## SERVICE LETTER 206

### 8750 Forward Spreader Bar Lift Support Replacement

<b>Aircraft Makes/Model(s):</b>	<b>Float Model(s):</b>	<b>Compliance:</b> Optional	<b>By:</b> MAB
Cessna 208, 208B	8750A, 8750S	<b>Part Number:</b> 1011366	<b>Approved:</b> SDW
		<b>Date:</b> 6/13/2022	<b>Revision:</b> B

**Spreader Bar Examples**

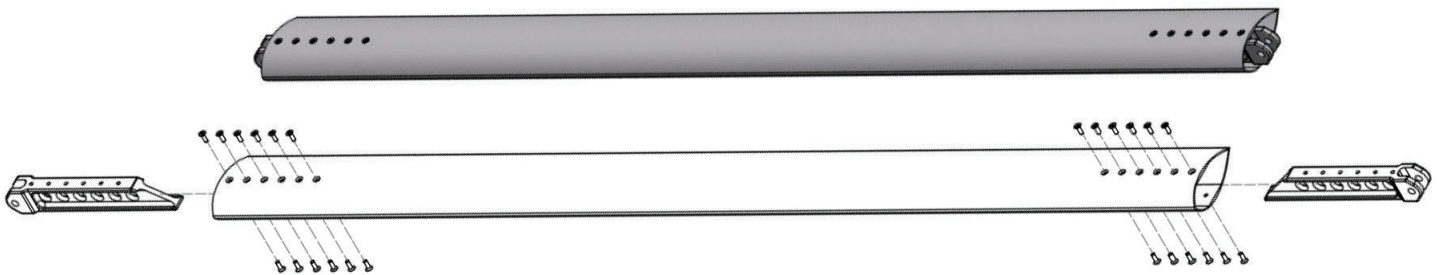
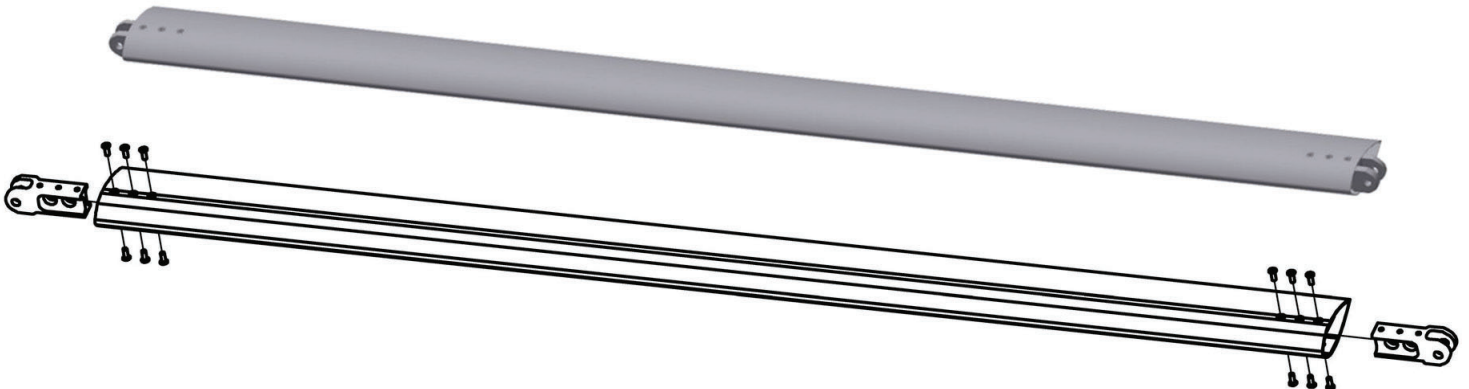
Some customers have expressed a desire for stronger spreader bars to facilitate ground operations. This service letter provides the option of installing the reinforced aft spreader bar from 8750 straight floats (PN 1009464) in place of any other 8750 spreader bar, both straight and amphibious floats.

**Reinforced Spreader Bar 1009464  
(Also Original Aft Spreader Bar on Straight Floats)**

**Straight Floats - Original Forward Spreader Bar 1009416**

**Amphibious Floats - Fwd and Aft Spreader Bar 1005341**

1. Position and prepare aircraft for safe maintenance.
2. Remove original spreader bar by unbolting from float fittings.
3. If in good condition, existing hardware may be used to fasten 1009464 spreader bar to floats.
